DEVELOPMENT ASSESSMENT REPORT

<b>Application No.</b>	DA/2022/0959
<b>Address</b>	53 Charles Street LEICHHARDT
<b>Proposal</b>	Substantial demolition and ground and first floor alterations and additions to existing dwelling house and associated works
<b>Date of Lodgement</b>	14 November 2022
<b>Applicant</b>	Mr Cameron J Campbell
<b>Owner</b>	Mr Cameron J Campbell and Mrs Alexandria A Campbell
<b>Number of Submissions</b>	Nil
<b>Value of works</b>	\$258,073.00
<b>Reason for determination at Planning Panel</b>	FSR variation exceeds 10% / Officer delegations
<b>Main Issues</b>	<ul style="list-style-type: none"> <li>▪ Non-compliances with Site Coverage and Floor Space Ratio development standards and inadequate Clause 4.6 Exceptions to Development Standards requests</li> <li>▪ Incompatibility with the desired future character</li> <li>▪ Inappropriate form, bulk and scale and design and appearance</li> <li>▪ Unsatisfactory on-site amenity outcomes</li> </ul>

<b>Recommendation</b>	Refusal
<b>Attachment A</b>	Reasons for Refusal
<b>Attachment B</b>	Plans of proposed development
<b>Attachment C</b>	Section 4.6 Exception to Development Standards
<b>Attachment D</b>	Conditions in the event

Building Envelope

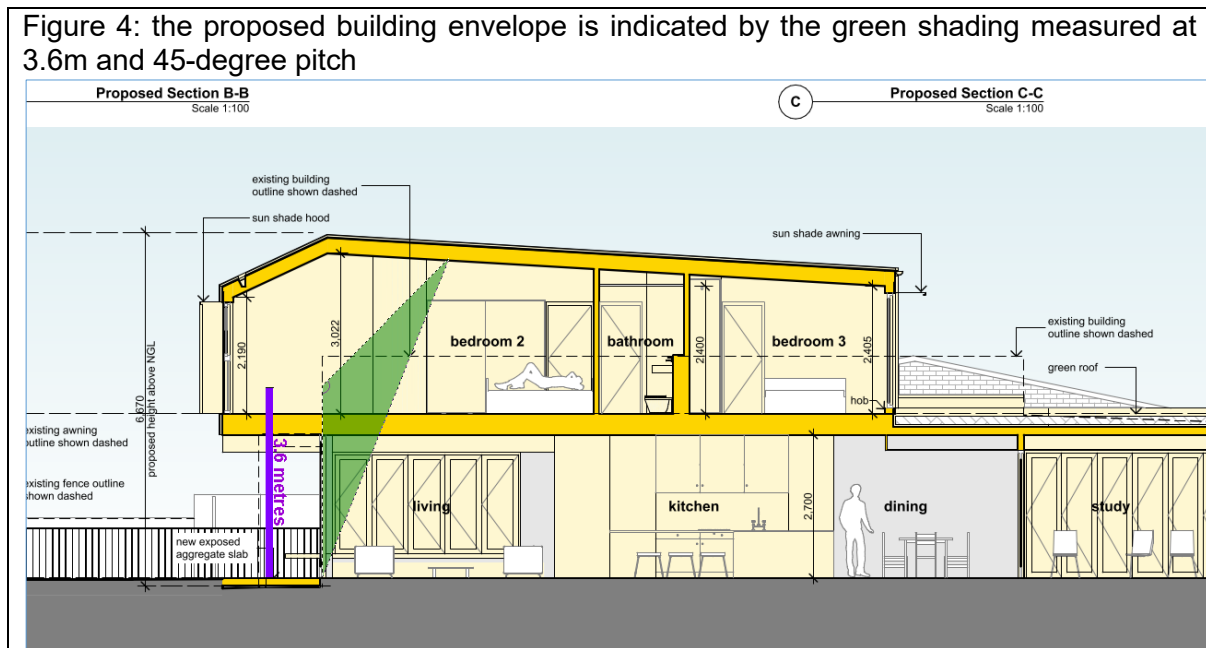
As can be seen in Figure 4 below, the proposed development breaches the 3.6m and 45 degrees pitch, therefore the proposed development is inconsistent with Control C16 of C3.2 of the LDCP 2013. That is, building envelope controls has two components: wall height and roof control of 45-degree inclined plane from the top of the wall height. Pursuant to Control C9 of C2.2.3.4 of the LDCP 2013, the applicable building wall height to the subject site is 3.6m.

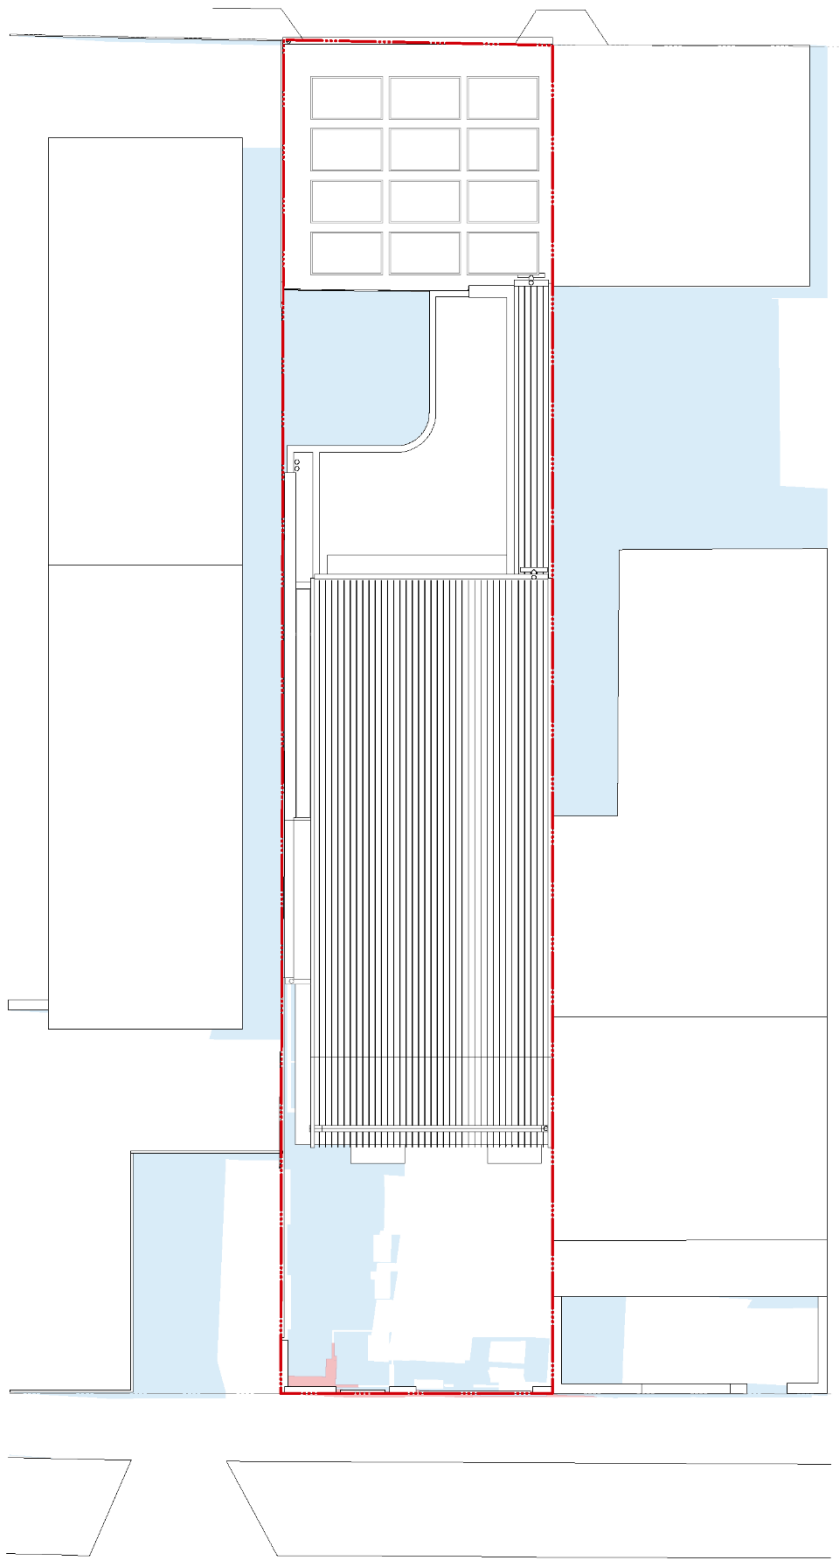
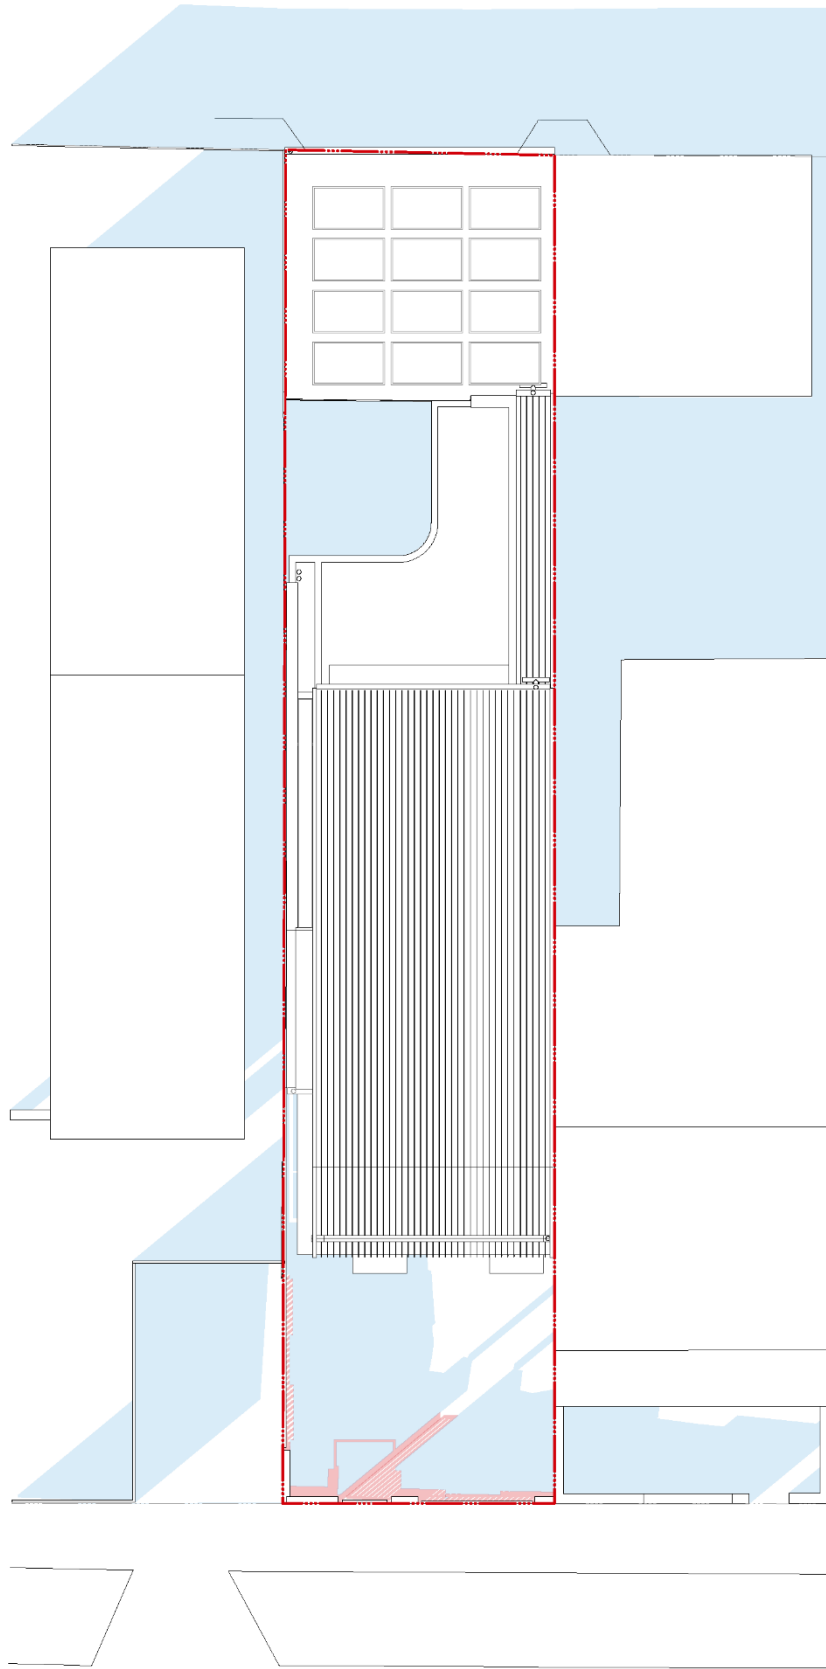
However, the proposed development does not provide a POS with a direct connection to the main living space (it is provided by the dining room). Further, the proposed POS does not have solar access from 9am to 3pm on 21 June as indicated by the submitted shadow diagrams as discussed in the Solar Access assessment below.

The submitted shadow diagrams demonstrates solar access to the subject site and adjoining properties to the north and south on plan view for 9am, 12pm and 3pm for 21 June, and 3D hourly diagrams of sun view for 21 June.
